# DEVELOPMENT REVIEW BOARD REPORT

SUBJECT	<b>Troon Canyon Estates II</b>
REQUEST	<p>Request Preliminary Plan approval for 11 single-family residences with amended development standards on a 40+/- acre parcel.</p> <p><b>26-PP-2004</b></p> <p><b>Key Items for Consideration:</b></p> <ul style="list-style-type: none"><li>• Roadway dedication of 122nd Street to include improvements from Alameda Road to the entrance of the proposed subdivision.</li><li>• The project conforms to the ESL requirements approved May 21, 2004.</li><li>• Building envelopes will be limited to areas outside of the hillside landform, peaks and ridges and boulder features.</li><li>• The site has upper desert and hillside landforms.</li><li>• Amended development standards for flag lots and widths only.</li><li>• The improvement of 122nd Street is an issue of concern for some citizens in the existing Sonoran Crest Development.</li></ul>
OWNER	<p>Credo Investments LLC 480-991-2288</p>

## **Stipulations for Case: 26-PP-2004 Troon Canyon Estates II**

# **PRELIMINARY PLAT FOR TROON CANYON ESTATES II** SCOTTSDALE, ARIZONA BEING A PORTION OF THE SOUTHWEST QUARTER OF SECTION 11, T-4-N, R-5-E OF THE G.&S.R.B.&M. MARICOPA COUNTY, ARIZONA

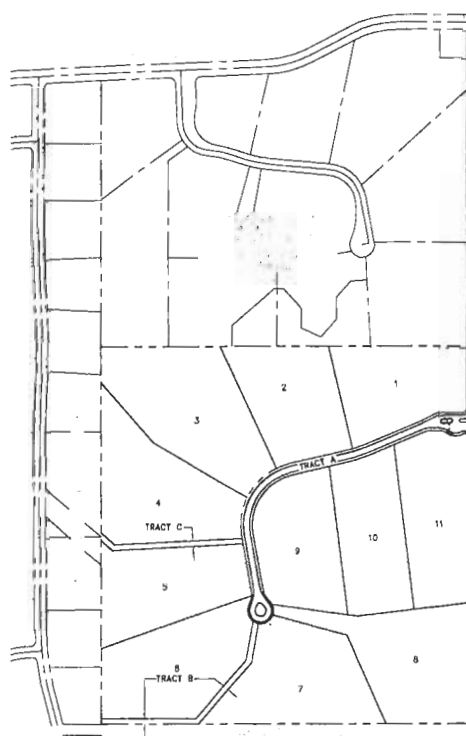
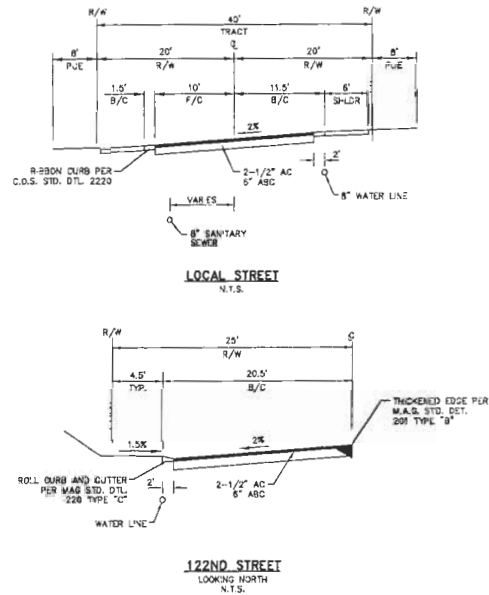
30. Preliminary Drainage Report is not accepted because the calculation for stormwater storage requirement shown on the Preliminary Drainage Report is incorrect. According to the City of Scottsdale Design Standard and Policies Manual Figure 2.2-17, for residential area average lot size Zoning R1-130, C value listed is 0.59. If this C value is selected for the storm storage volume (Vr) calculation, the gross area shall be used. If choosing to use the disturbed areas for the Vr calculation, the "weighed" C value need to be calculated and used in the Vr calculation. For the weighed C calculation, C = 0.95 shall be used for the paved areas (driveways and roofs) and C = 0.83 shall be used for desert landscaping areas. The final drainage report and final plat shall reflect correct Vr calculation and provide adequate stormwater storage volume.

Proposed Entry Gates

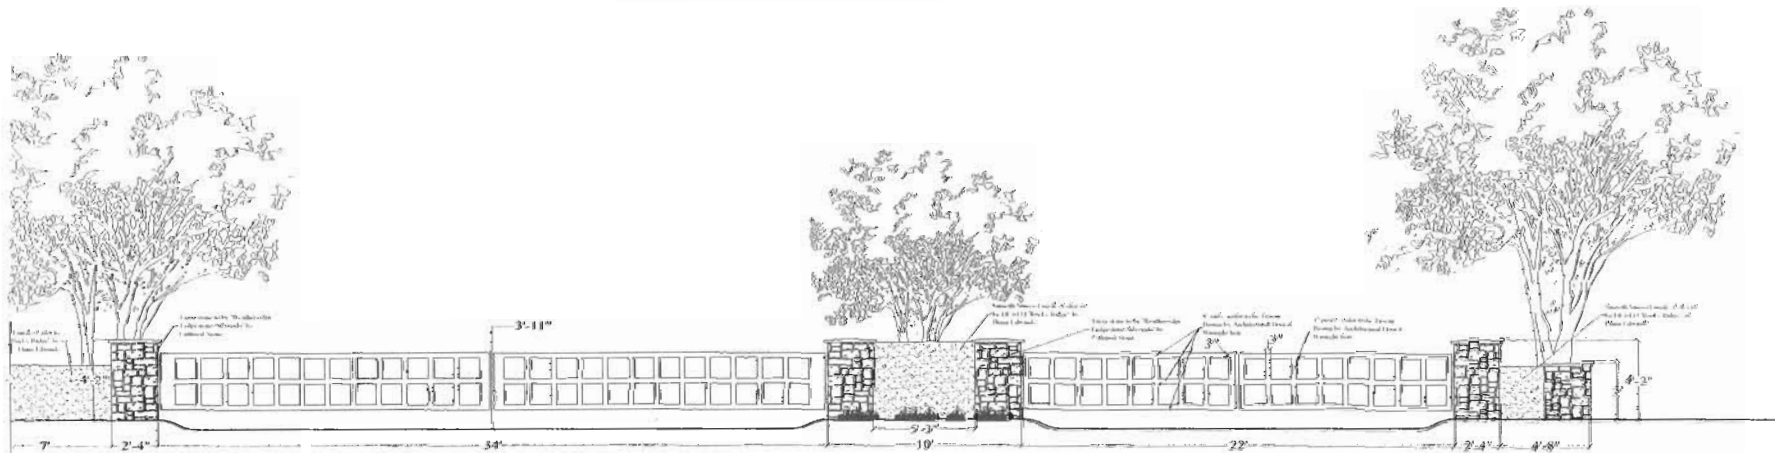
- G. Any entry gate walls or fences that reside in the front yard of Lots 1 and 11 shall be a maximum height of three (3) feet.

40. Where a gated entrance is proposed, the developer shall design and construct the gated entrance in conformance with Figure 8.1-1 of the City's Design Standards and Policies Manual

42. Provide pedestrian access around the private gated entrance.
